CITY OF ALBUQUERQUE

July 20, 2015

**Re: Winrock Redevelopment Section 2 and Section 4 Grading and Drainage Plan
Engineer's Stamp Date 7-20-15
Drainage file number (J19D058C)**

DATE	07/20/15	SHEET	X
SCALE	1"=100'	C101	of XX

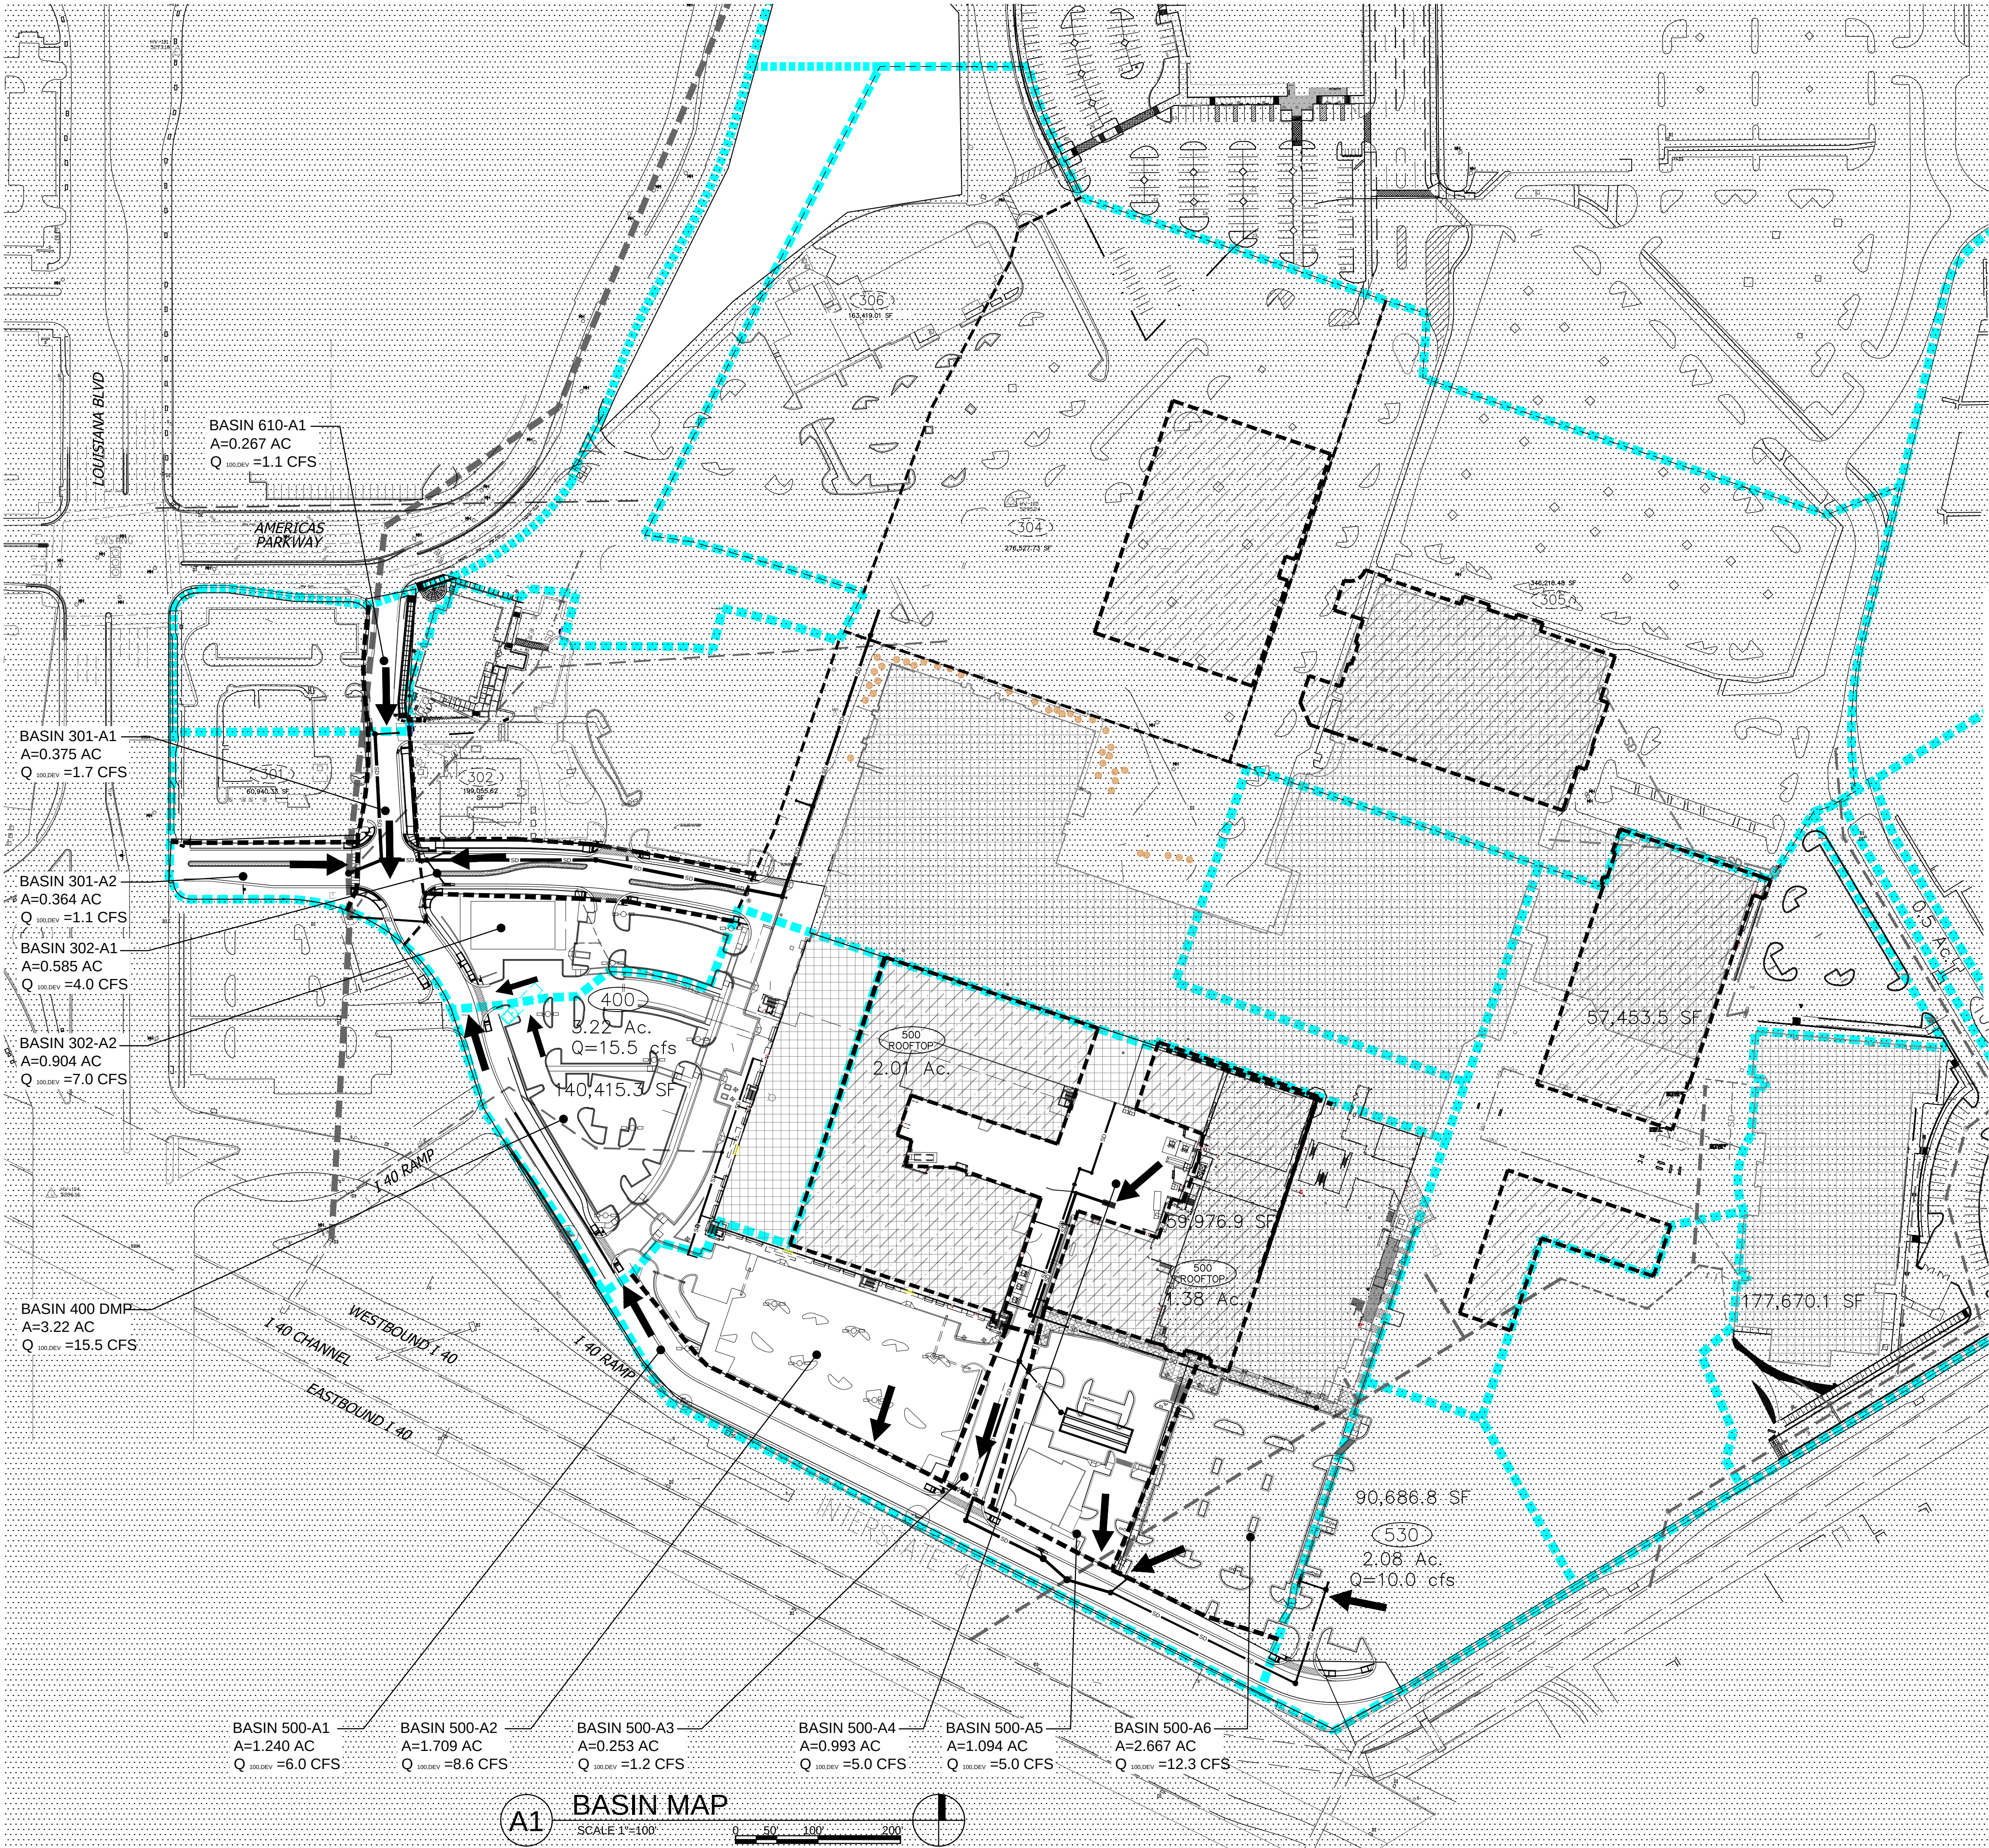
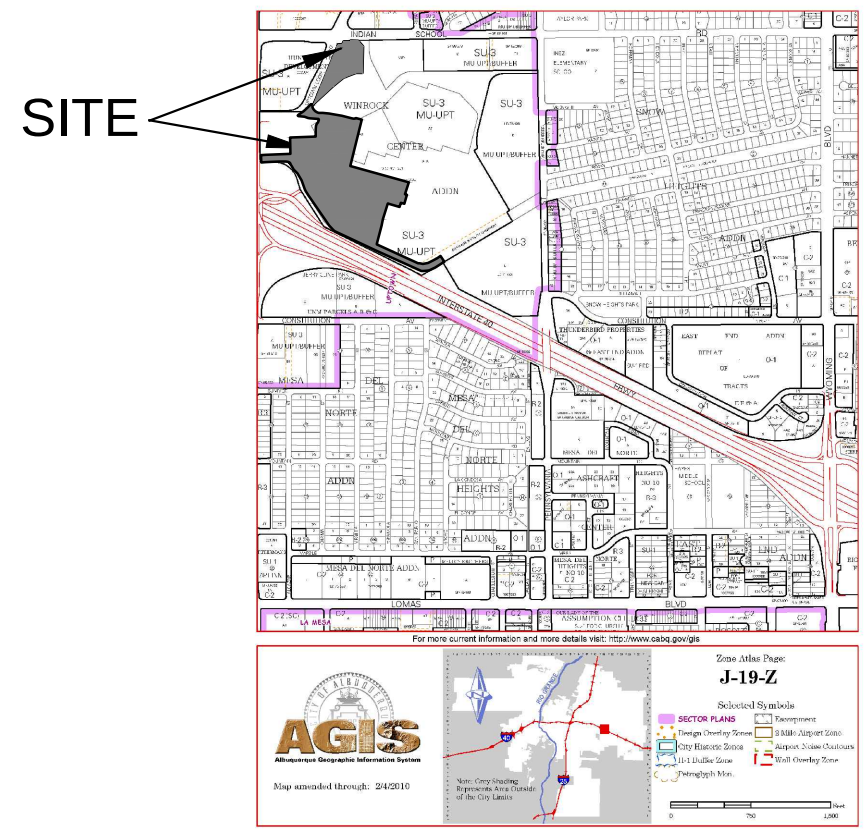
11. As a note for future submittals, the manning's coefficient for streets is 0.017, not 0.013. The street had excess capacity using 0.013, so it should work if 0.017 was used.
12. On Sheet C101, correct the flows on Basins 302-A1 and 302-A2 to 2.8 cfs and 4.2 cfs, respectively.

A1 FIRST FLUSH & STORM DRAIN LAYOUT
SCALE: 1"=100'

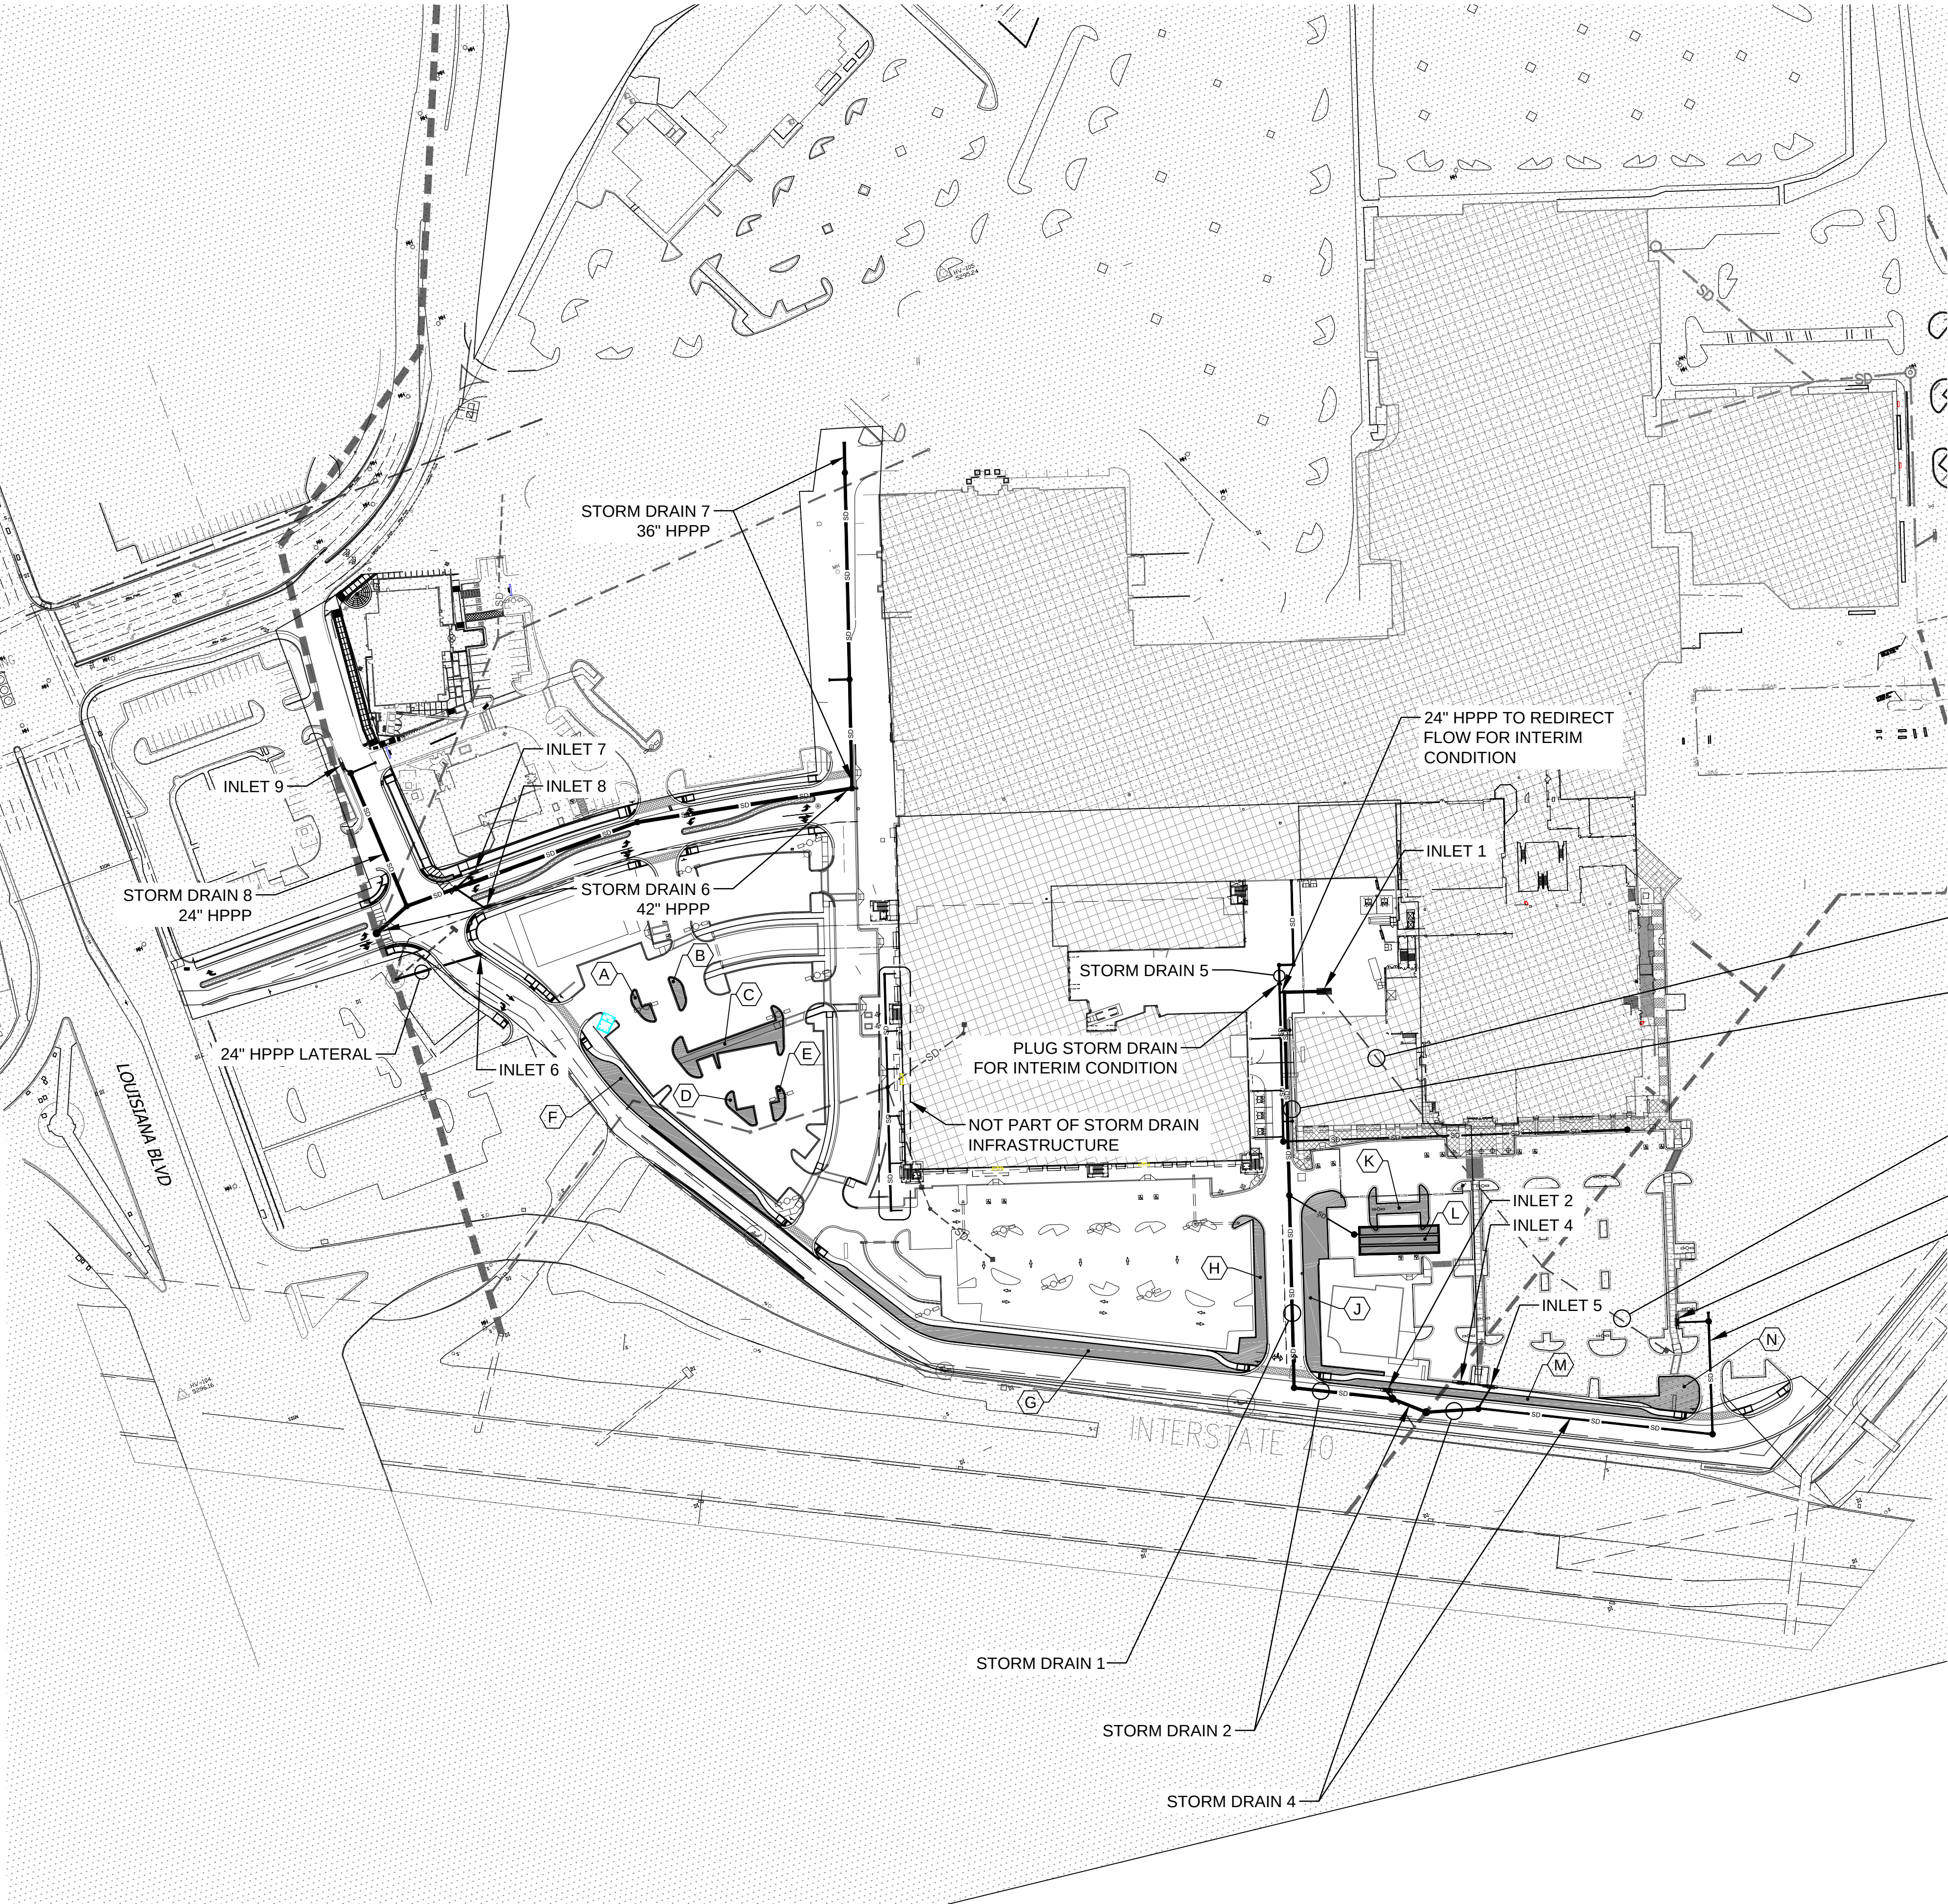
1. Storm drain sizes as shown on Sheet C103 should be included in the Work Order, not C100 and C102, for the outfall to the 84" existing storm drain.
2. The narrative states that rooftop basins will be directed to the water feature for treatment. This should be revised to state that the first flush from rooftops will be treated by an underground retention system in the interim condition.
